14 CFR Part 36
Noise Certification Regulations for
Helicopters; Proposed Rule

[Docket No. FAA-2000-7958; Notice No. 00-11]

Noise Certification Regulations for Helicopters

ACTION: Notice of Proposed Rulemaking (NPRM).

Figure H1.
Comparison of Measured and Reference Takeoff Profiles

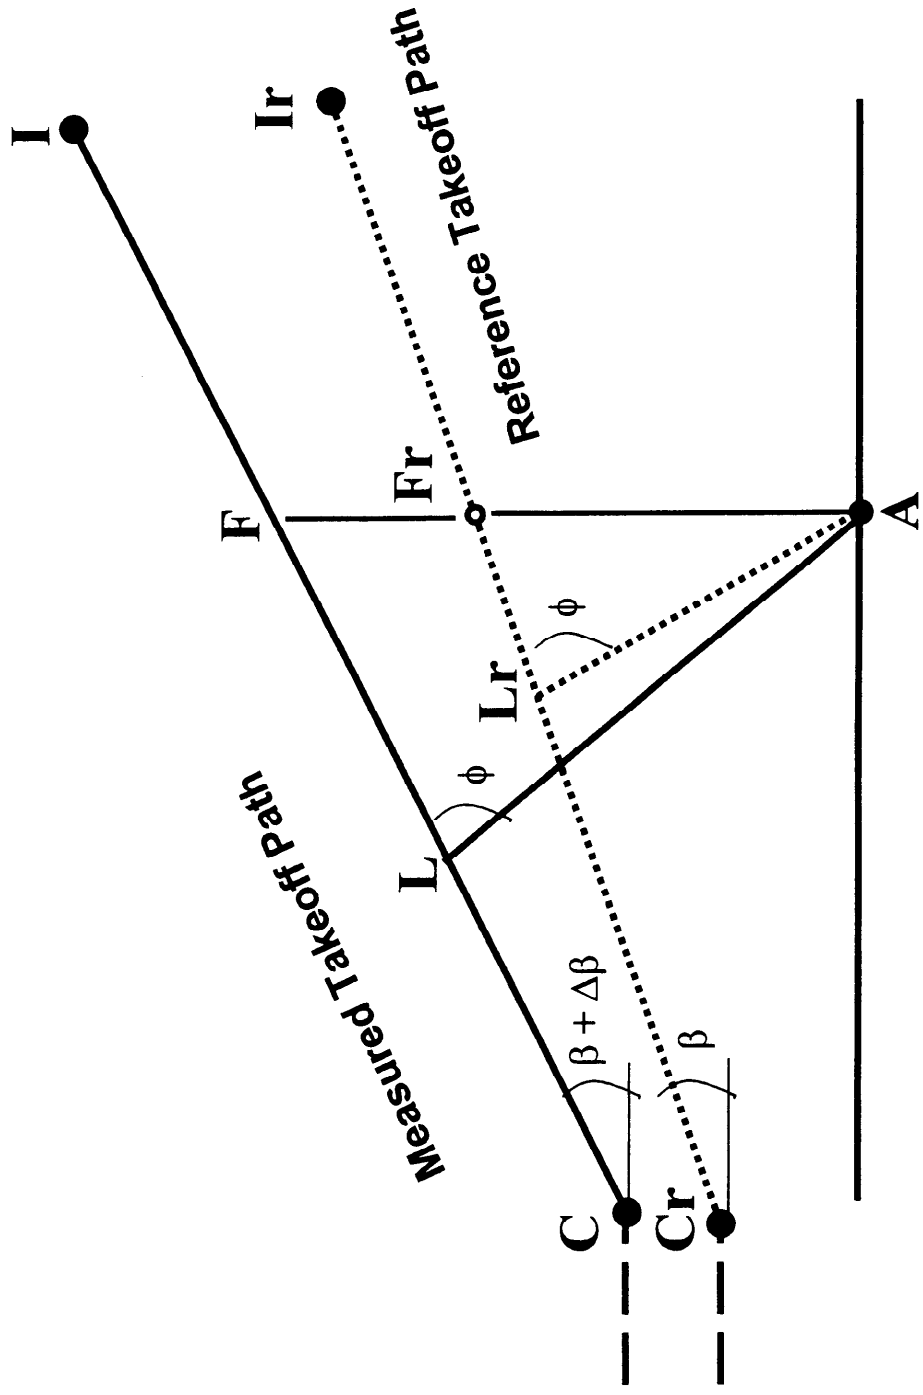
Proposed revision to Figure H1 deletes the designation of Positions Tr since the minimal distance designation is no longer needed and includes the height above measurement point in metric units; see the text of proposed section H36.205(b)(3) regarding the takeoff condition.

In proposed Figures H1, H2, and H3 the titles of the figures are changed to reflect the language of this proposal. The word "reference" would replace the word "corrected" in each title.

Figure H2.
Comparison of Measured and Reference Flyover Profiles

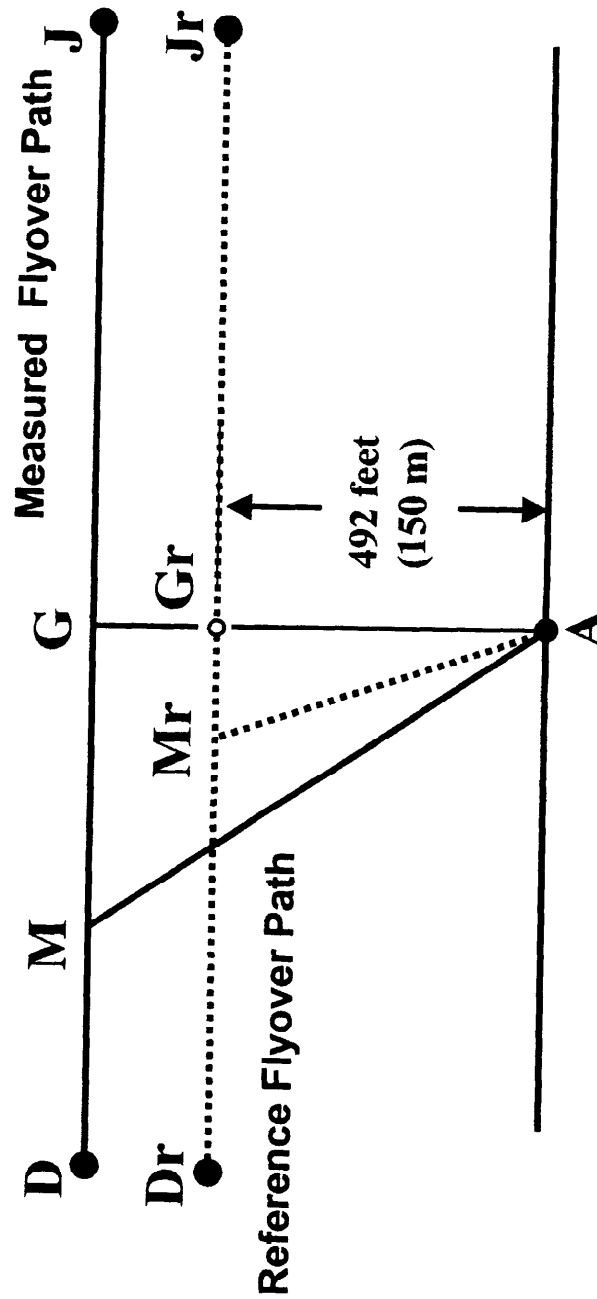
Proposed revision to Figure H2 repositions the bullet-marker that's incorrectly positioned near label G due to a typographical error. The marker is repositioned in the proposed revised graphic image at the intersection of line Dr-Jr and line A-G.

Figure H3.
Comparison of Measured and Reference Approach Profiles

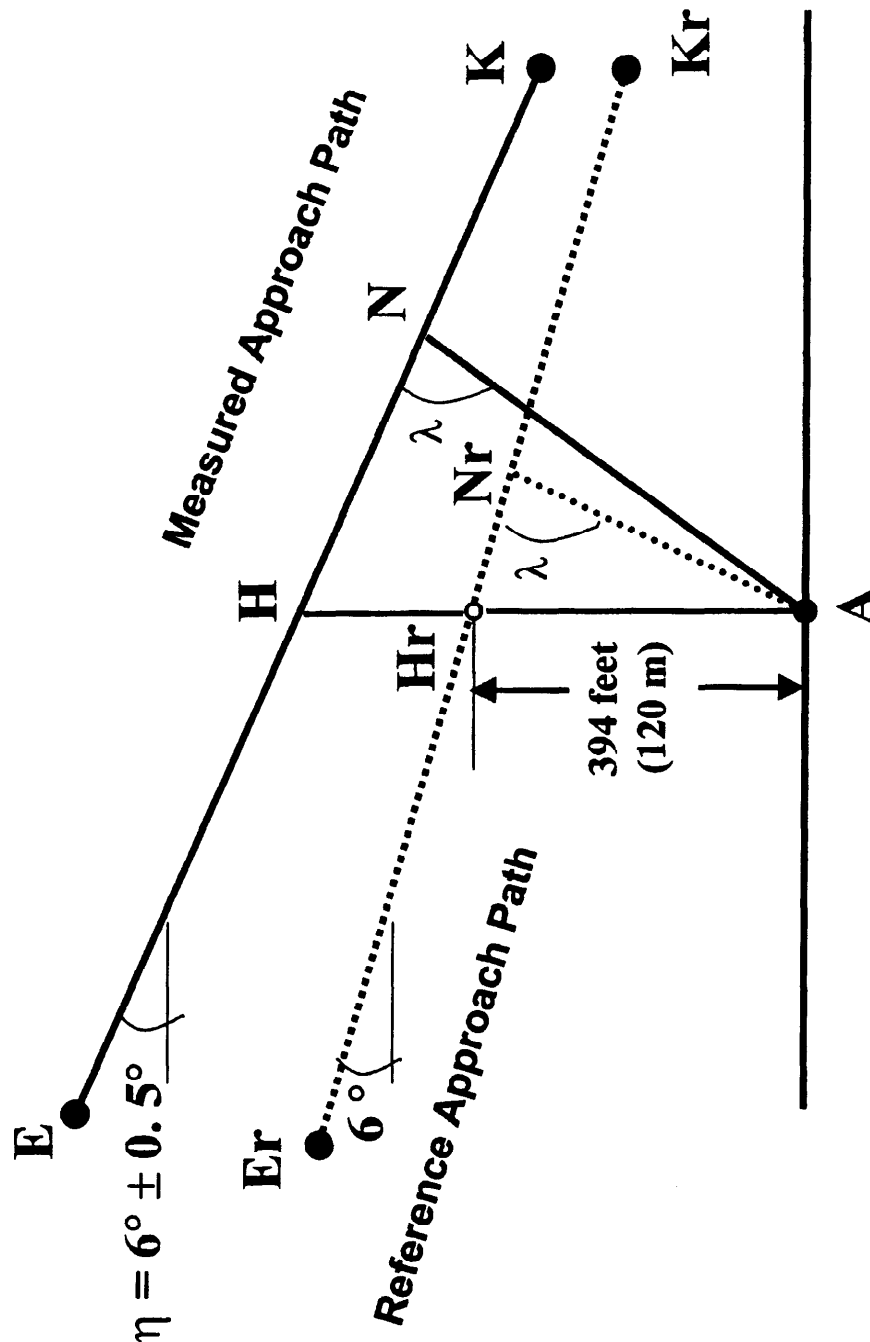
Proposed revision to Figure H3 deletes the designations of Positions S and Sr since the minimal distance designation is no longer needed and includes the height above measurement point in metric units; see the text of section H36.205(d)(3) regarding the approach condition.
